Access Compliance Report

Public Rights-of-Way

Intersection ID: 15013	Main Street: E_WORTHINGTON_AV	Cross Street: EWING_AV	Location:	S
ADA ID: B357939C7C19	Ramp Type: Perp	Initial Pass/Fail: Fail	Overall Compliance: No	Severity Score: 1.25
Codes/Mitigation Info/Possible Solution		Field Measurements/Component Compliance

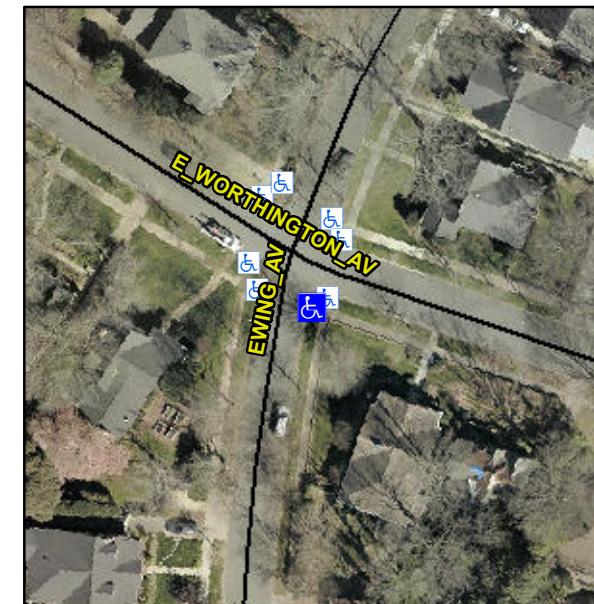
R304.5.3

Compliance	Description	Data	Compliance	Description	Data
N/A	Ramp Length (in)	70.0	Yes	Ramp Slope (%)	6.7
Yes	Ramp Width (in)	48.0	No	Ramp XSlope (%)	4.3
N/A	Flare Type LT	N/A	N/A	Flare Type RT	N/A
N/A	Flare Slope LT (%)	N/A	N/A	Flare Slope RT (%)	N/A
N/A	Flare Traversable LT?	N/A	N/A	Flare Traversable RT?	N/A
N/A	Landing Length (in)	N/A	N/A	DWS Provided?	N/A
N/A	Landing Width (in)	N/A	N/A	DWS Contrast?	N/A
N/A	Landing Slope (%)	N/A	N/A	DWS Length (in)	N/A
N/A	Landing X Slope (%)	N/A	N/A	DWS Full Width?	N/A
N/A	Landing Curb? (Y/N)	N/A	N/A	DWS Offset (in)	N/A
N/A	Shared Landing?	N/A			
N/A	Gutter Ponding?	N/A	N/A	Gutter Slope (%)	N/A
N/A	Gutter Lip Ht (in)	N/A	N/A	Gutter X Slope (%)	N/A
N/A	Painted X Walk1?	No	N/A	Painted X Walk2?	N/A
	X Walk 1 Direction	To NW		X Walk 2 Direction	N/A
N/A	X Walk 1 Width (in)	N/A	N/A	X Walk 2 Width (in)	N/A
	X Walk 1 Slope (%)	4.0		X Walk 2 Slope (%)	N/A
	X Walk 1 X Slope (%)	0.9		X Walk 2 X Slope (%)	N/A

Remove & Replace Entire Ramp.
